Model: Decurl Unit DU5000 (D457)	Date: 09-Sep-09	No.: RD457001a
----------------------------------	-----------------	----------------

Subject: Undetected roller unit due to deformed feeler		Prepared by: K. Tsutsui	
From: PPMC Service Planning Department 1G			
Classification:	<input type="checkbox"/> Troubleshooting <input type="checkbox"/> Mechanical <input type="checkbox"/> Paper path <input type="checkbox"/> Product Safety	<input type="checkbox"/> Part information <input type="checkbox"/> Electrical <input type="checkbox"/> Transmit/receive <input type="checkbox"/> Other ()	<input checked="" type="checkbox"/> Action required <input type="checkbox"/> Service manual revision <input type="checkbox"/> Retrofit information <input type="checkbox"/> Tier2

Model: Bellini-C4(Katana-C2)		Date: 09-Nov-09	No.: RD059045
Subject: Adjustment of Decurl Unit DU5000		Prepared by: K. Tsutsui	
From: PP Service Planning Department 1G			
Classification:	<input type="checkbox"/> Troubleshooting <input type="checkbox"/> Mechanical <input type="checkbox"/> Paper path <input type="checkbox"/> Product Safety	<input type="checkbox"/> Part information <input type="checkbox"/> Electrical <input type="checkb

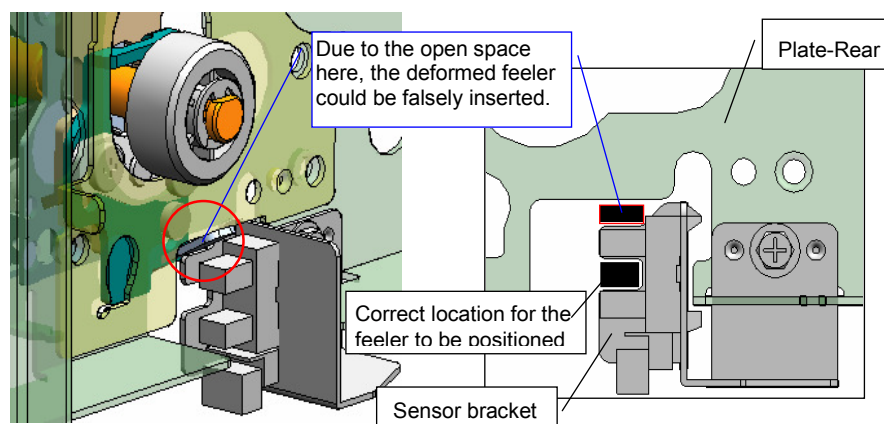
The decurl unit set sensor cannot detect the feeler when the feeler is falsely inserted into the area colored red in the following diagram.

Fix the bent feeler with pliers or a similar tool so that the feeler will be inserted into the correct position and detected by the decurl unit set sensor.

Deformed sensor bracket

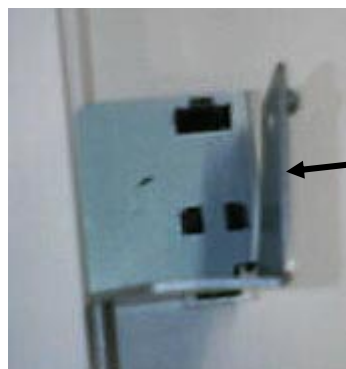
In addition to the above "countermeasure 1", please replace with the modified sensor bracket if it is deformed.

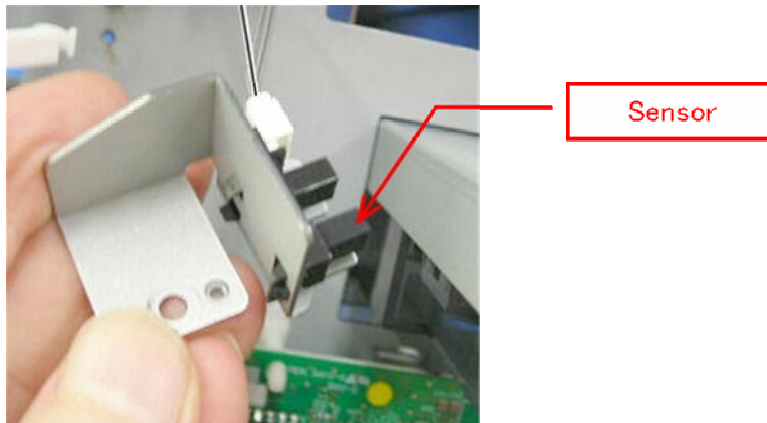
3. Remove the sensor from the sensor bracket.**Replacing with the MODIFIED Bracket****Replace with the modified Roller Unit Set Detection Sensor Bracket.****Old version
D4574232A****Modified
D4574233****Assembly of the Unit****Follow the above steps in reverse order for assembly and installation of the unit.****IMPORTANT****Please be careful not to damage the sensor harness.**

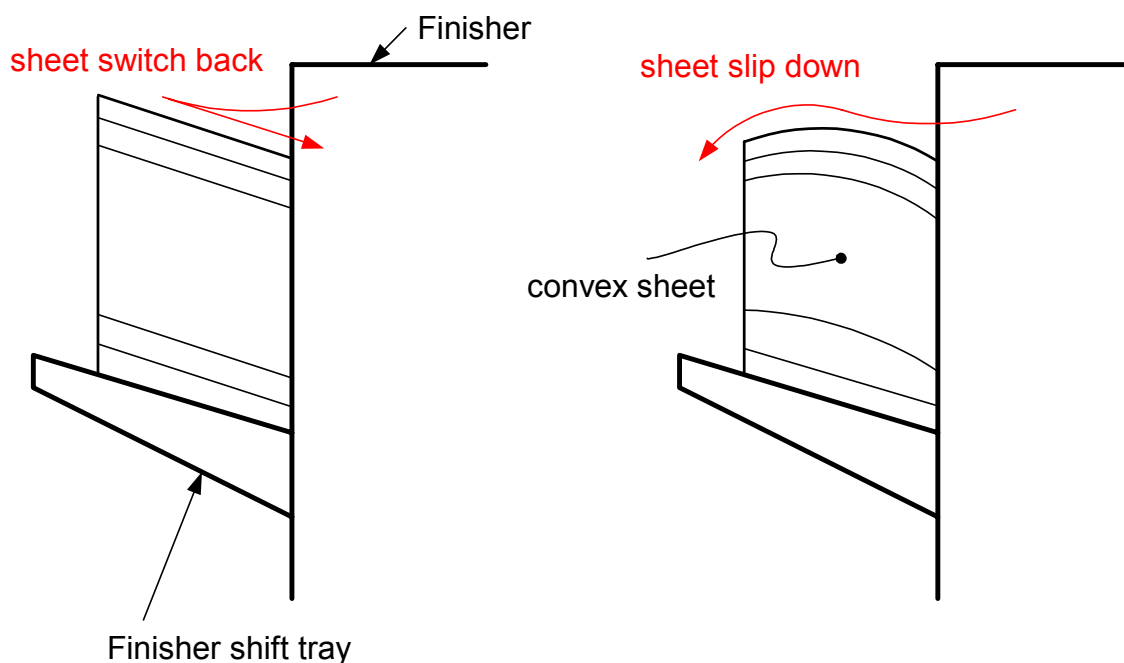
When convex-curved sheets are stacked on the Finisher shift tray, they could slip down from the tray to the ground.

The exited sheets are switched back on the Finisher shift tray, which is at an angle. However, when the sheets have convex curl and are stacked in a large amount, the slope becomes flat at the top of the stack. The flat stack stops the exited sheets from switching back and causes them to slip over due to their momentum.

Set the de-curl roller unit upside down and adjust the value in the User Tools. Refer to the service manual and the operation manuals.

Placement figure

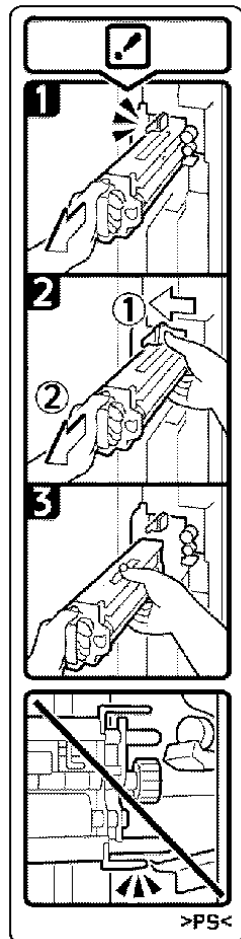
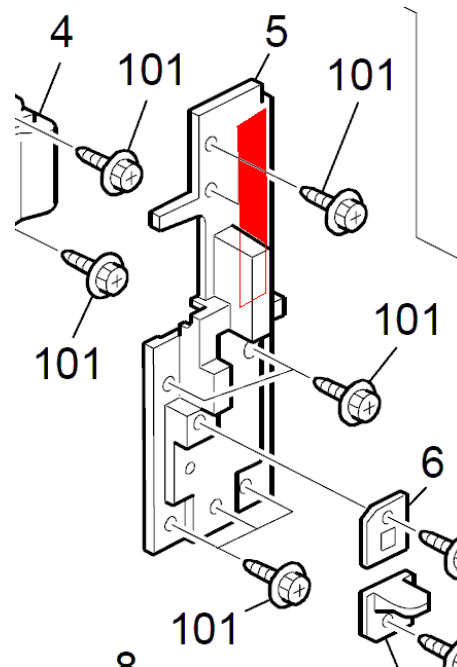
Symptom: Feeler bent in the roller unit.

Solution: Added a decal to draw attention.

3.Decurl Section 1 (D457)

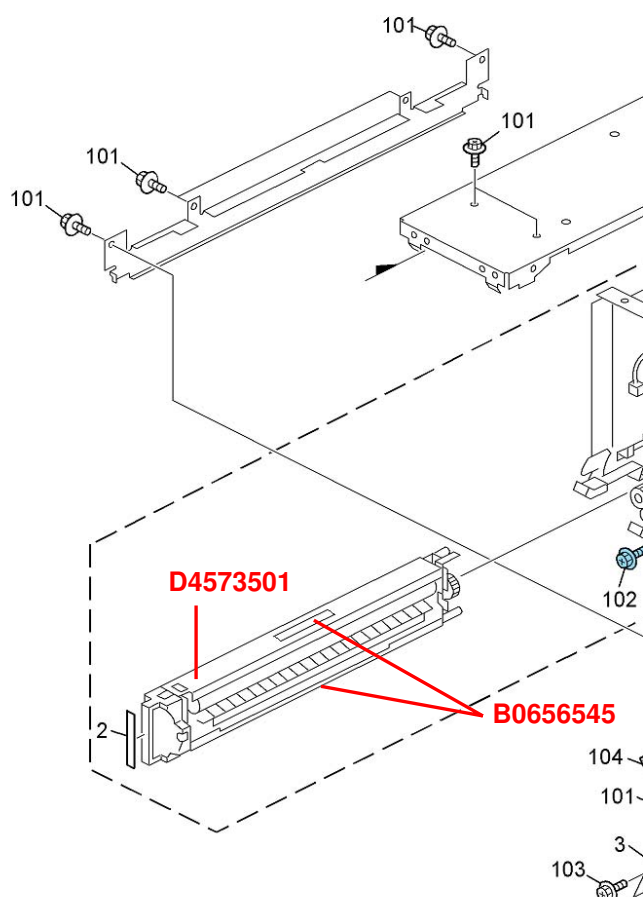
New part number	Description	Q'ty	Page	Index	Note
D4573501	ROLLER:DECURA:ASS'Y	1	6	-	Add
B0656545	DECAL - POSITIONING	2	6	-	Add

Change: Parts were added.

*Please attach the decal B0656545 to the top and bottom of D4573501 if necessary

NOT Modified**Modified**

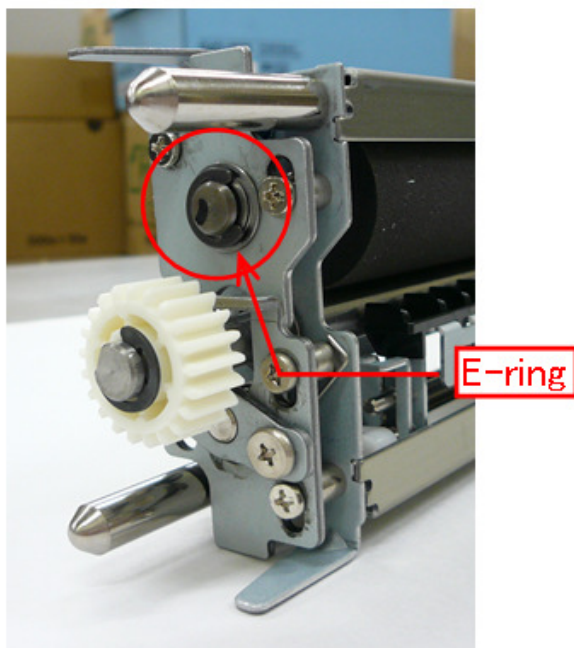
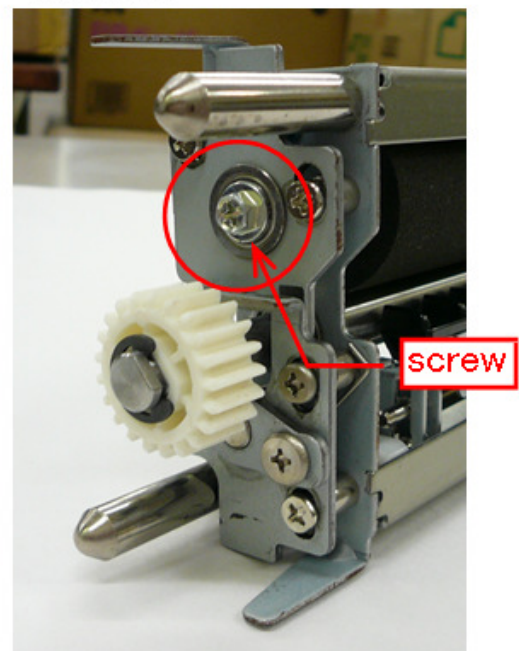
2. Check the area circled in the photos below, located at the rear of the unit.

Please replace the Decurl Unit Ass'y with the modified Decurl Unit (P/N: **D4579901** MODIFICATION :DECURA) on your next service visit.

Replace with the modified unit if the “NOT Modified” version is installed.

3.Decurl Section 1 (D457)

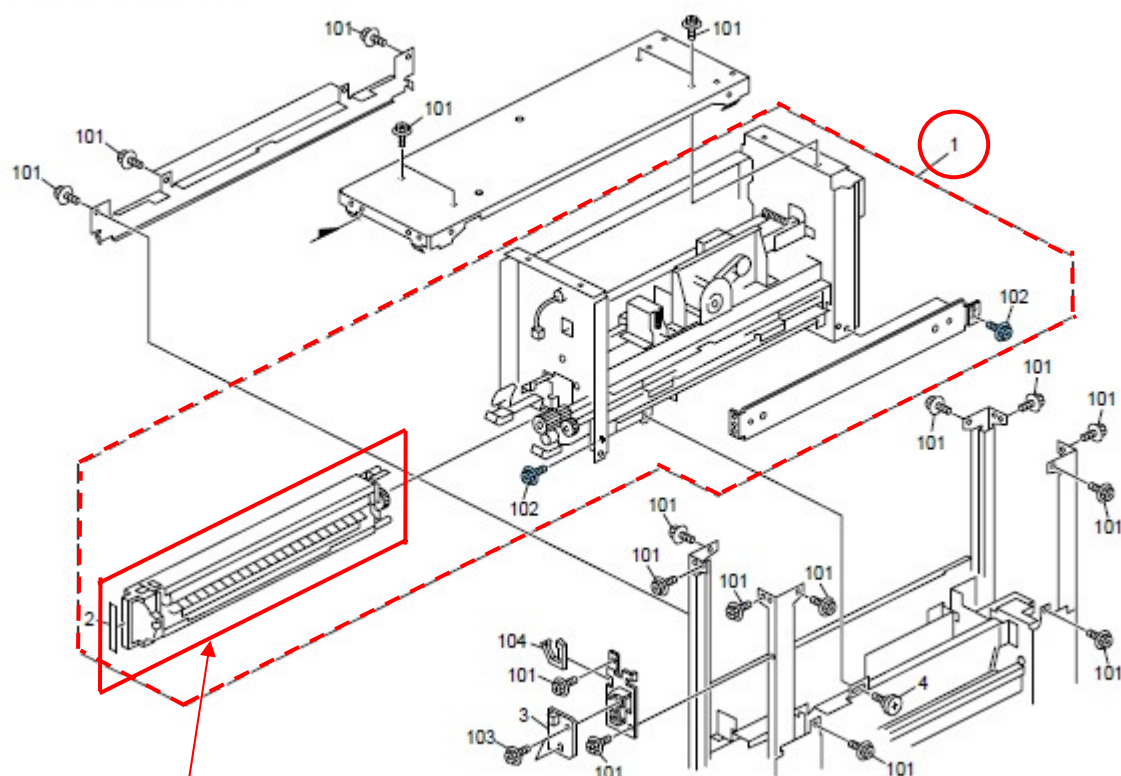
Change: The roller in the transport unit was modified.

Reason: Higher reliability; longer life of the roller

Old Part Number	New Part Number	Description	Q'ty	Int	Page	Index	Note
D4570192	D4570193	TRANSPORT SECTION: DECURA UNIT	1	X/O	7	1	-
D4573502	D4573503	ROLLER: DECURA: ASS'Y	1	X/O	7	5	-

4.Decurl Section 2 (D457)

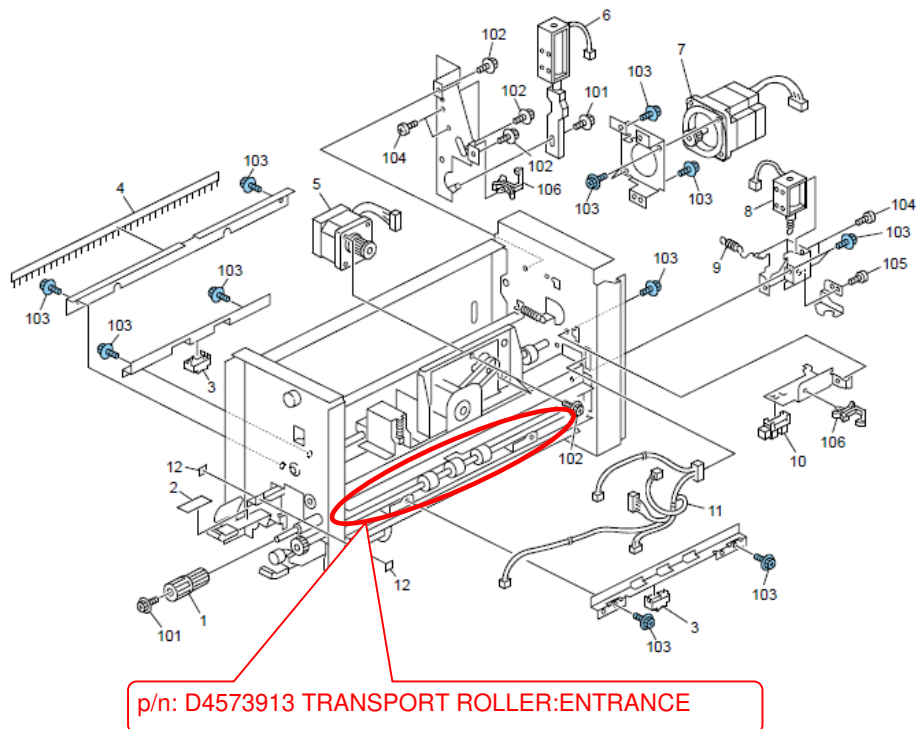
Old p/n	New p/n	Description	Q'ty	Int	Page	Index	Note
-	D4573913	TRANSPORT ROLLER:ENTRANCE	1	-	9	13	Add

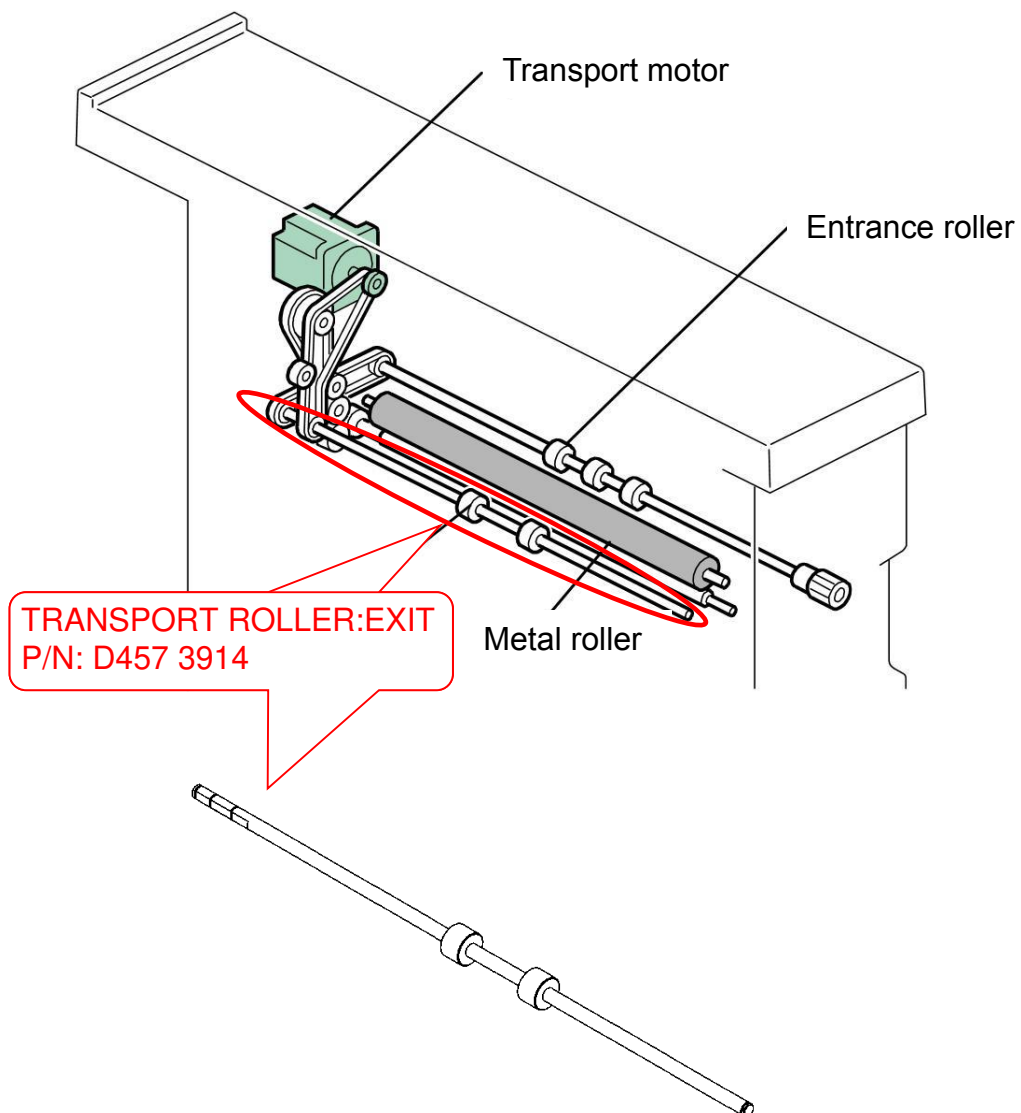
Old p/n	New p/n	Description	Q'ty	Int	Page	Index	Note
-	D4573914	TRANSPORT ROLLER:EXIT	1	-	9	14	Add

4.Decurl Section 2 (D457)

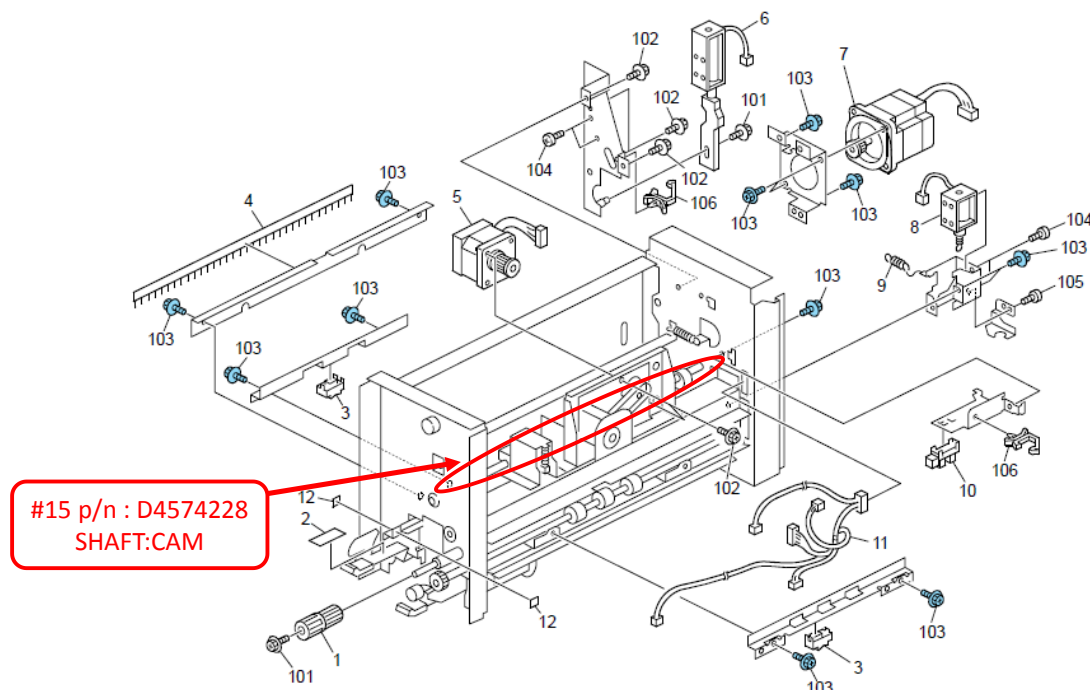
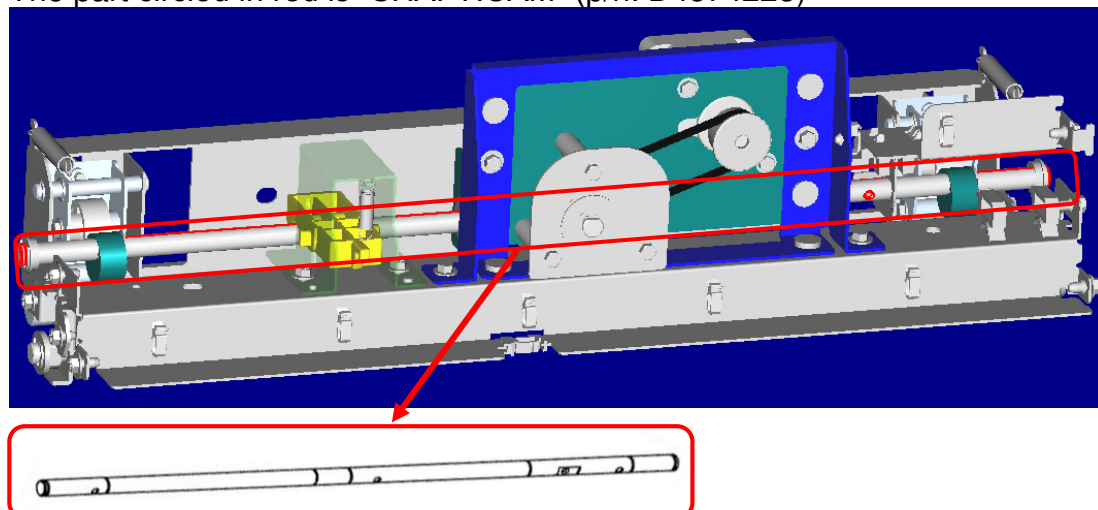
Old p/n	New p/n	Description	Q'ty	Int	Page	Index	Note
	D4574228	SHAFT:CAM	1	-	9	15	Add

The part circled in red is “SHAFT:CAM” (p/n: D4574228)

4.Decurl Section 2 (D457)

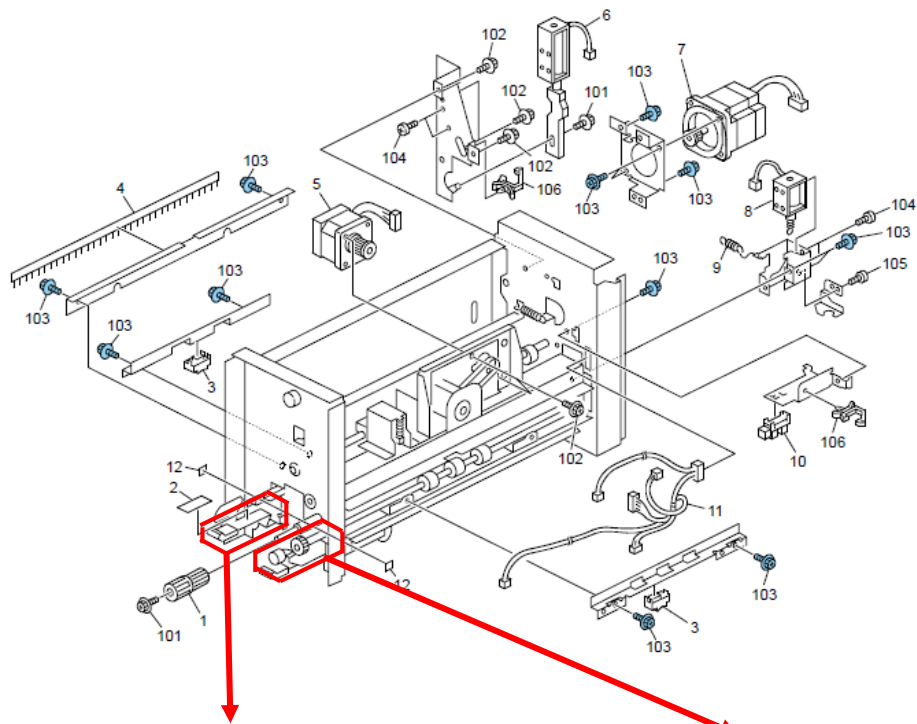
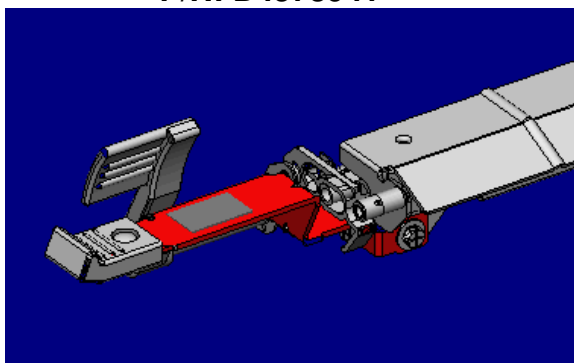
Old p/n	New p/n	Description	Q'ty	Int	Page	Index	Note
-	D4573941	HANDLE:GUIDE PLATE:LOWER LEFT	1	-	9	16	Add
-	D4573925	LINK:LEVER:GUIDE PLATE:LOWER RIGHT	1	-	9	17	Add
